## REQUEST

Current Zoning: MUDD-O (mixed use development, optional)  
Proposed Zoning: MUDD-O SPA (mixed use development, optional, site plan amendment)

The petition proposes a site plan amendment to a previously approved site plan allowing redevelopment of an infill parcel for a mixed use commercial building in the Montford Park area south of the Park Road Shopping Center.

### • Proposed Request Details

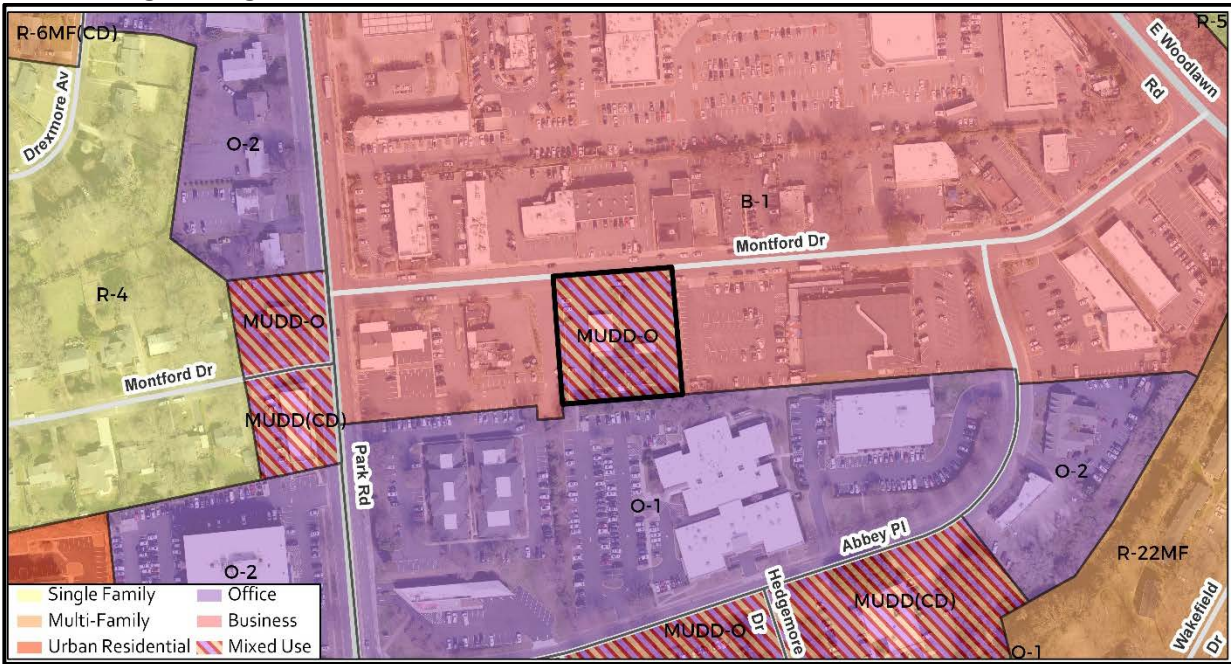
1. ~~Amend the sidewalk and planting strip shown along the unnamed side street to match what is stated in Note 5.a. specifying a 16-foot setback with an eight-foot planting strip, with hardscape sections connecting the curb to the sidewalk a minimum eight-foot sidewalk which may extend to the building façade.~~ Addressed.
2. ~~Amend the label for the setback on the unnamed side street to specify if it is existing or future back-of-curb.~~ Addressed, the existing curb line is specified because the curb is in the future location.

3. ~~Revise the site plan and conditional notes to stub across access drive to the adjacent parcel (PID 17514501) per Transportation Policy T-4 in the *Park Woodlawn Area Plan*.~~ Staff rescinded this request. The petitioner has stated that cross access would impede the proposed parking structure and that the neighboring property does not support cross access. The prior rezoning did not include cross access.

4. ~~Revise the site plan to create bump-outs for on-street parking on Montford Drive.~~ Addressed; the petitioner has committed to provide a bump out on Montford Drive at the unnamed street. The petitioner has stated that there is not infrastructure at this location to deal with potential water runoff issues from additional bump outs along Montford. The petitioner will further discuss these matters at permitting should the infrastructure exist at that time. During the prior rezoning similar stormwater issues along Montford Road were discussed. The proposed streetscaping is the same as approved by Council with staff support.

5. ~~For clarity, under Note 3 Permitted Uses, add that, "No accessory drive-through windows shall be permitted."~~ Addressed.
